From: Ferrante, Fernando *mlr*
Sent: Tuesday, August 17, 2010 7:00 PM
To: James, Lois
Subject: IN on NSAC/60
Attachments: NSAC60 Discussion.docx

DISCUSSION ON THE HISTORICAL USE OF DAM FAILURE RATES IN PROBABILISTIC RISK ASSESSMENT OF OPERATING NUCLEAR POWER PLANTS IN THE US

Figure 2. Comparison of results for the cumulative distribution of the PMP frequency

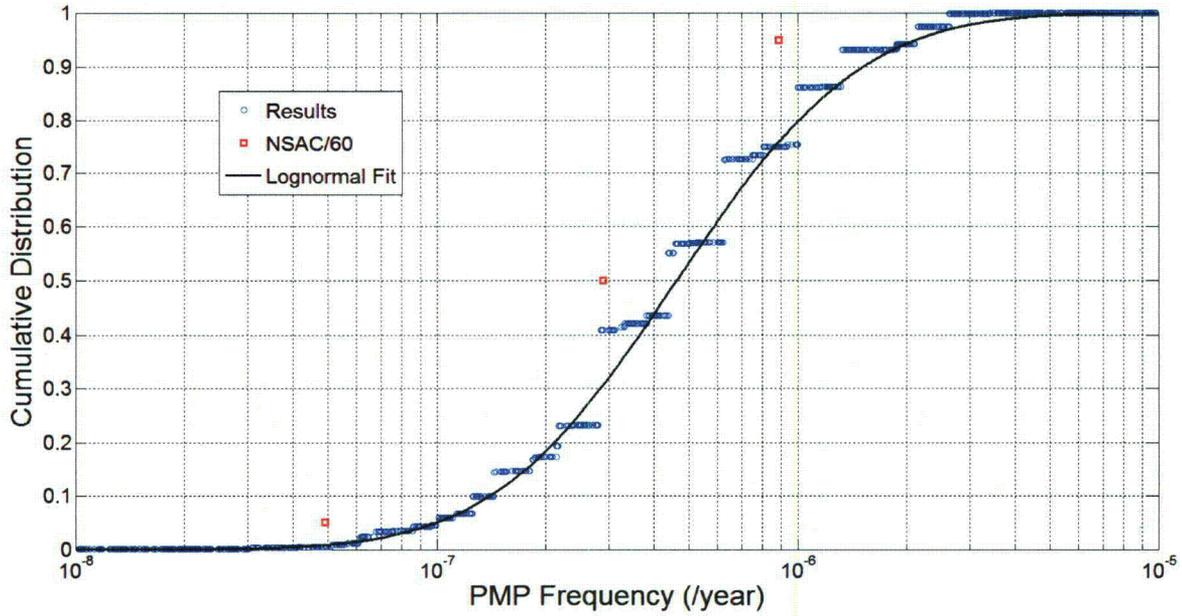
A comparison of the results is shown in Figure 2. The results from NSAC/60 (Page 9-117) appear to under predict the replicated values where, for example, the 95th percentile is obtained as 1.6E-6/year versus the NSAC/60 result of 8.9E-7/year. Since the original analysis is not available, it is difficult to assess whether this difference is due to numerical calculations, data input, or another cause. Ultimately, the real challenge in the analysis presented is the justification for extrapolating limited data to such extreme low values. As good practice dictates, the higher and more refined the quality of the data, the more supportable the justification for extrapolation becomes. As far as extreme precipitation phenomena are concerned, the issue of frequency estimation has been debated by several US federal agencies and entities involved with hydrologic applications. A good summary of the state-of-the-art is provided in the 1999 joint report by Utah State University and the US Bureau of Reclamation titled "A Framework For Characterizing Extreme Floods for Dam Safety Risk Assessment," where the limits of credible extrapolation for annual exceedance probabilities are set at 1/100,000 with the inclusion of optimal data inputs (i.e., best combination of data), beyond what is presented in NSAC/60.

Figure 3. Comparison of dam failure rate estimates for dams built between 1900 and 1981

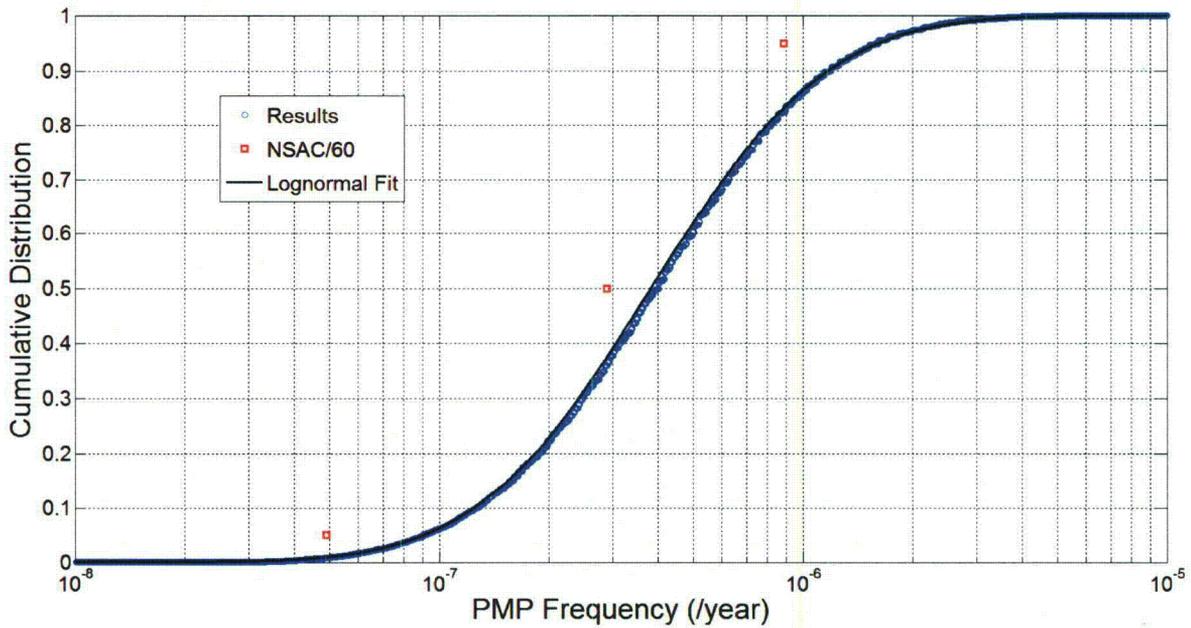
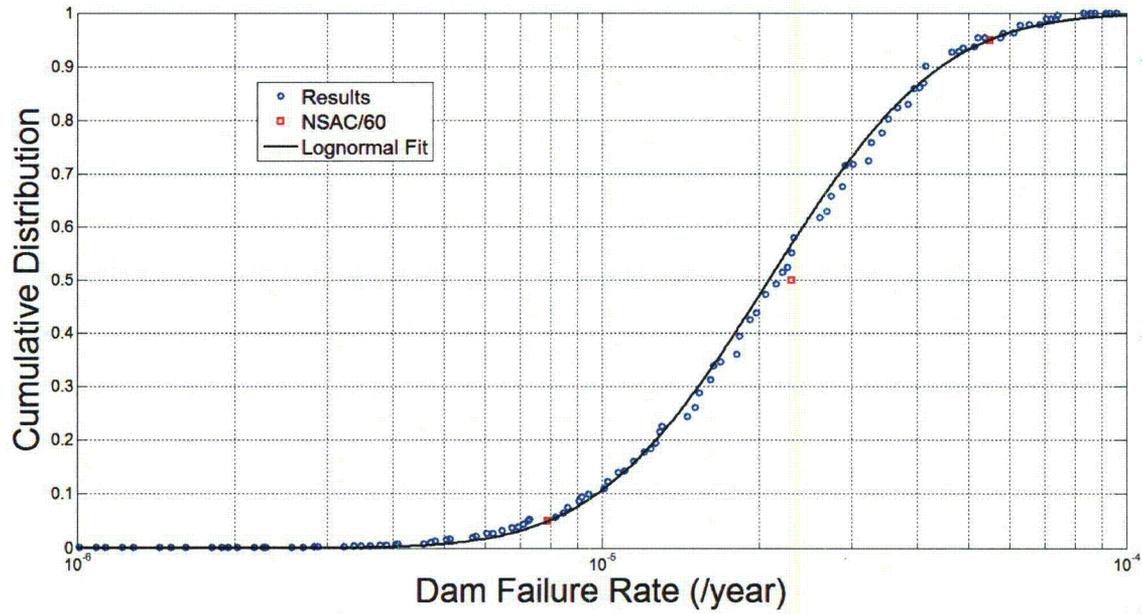
The results for dams built after 1900 (see Figure 3) show that the analysis with the original grid compares well with the NSAC/60 results. However, using a more refined grid indicates that the Bayesian updating used is sensitive to the grid arrangement. The 95th percentile with the more refined grid is 4.3E-5/year, compared to the NSAC/60 value of 5.5E-5/year. Overall, the results for the dam failure rate and the PMP frequency are close enough for the purposes of validating the result and the noted differences are not significantly different, despite the discrepancies observed. Additionally, the different periods considered in the study were compared to the results presented in NSAC/60 (see Figure 4), where at each overlapping period interval only those failures applicable are considered (i.e., 5 failures between 1900 and 1981, 2 failures between 1940 and 1981, and 1 failure between 1960 and 1981), with a recalculated number of dam-years is derived for each period.
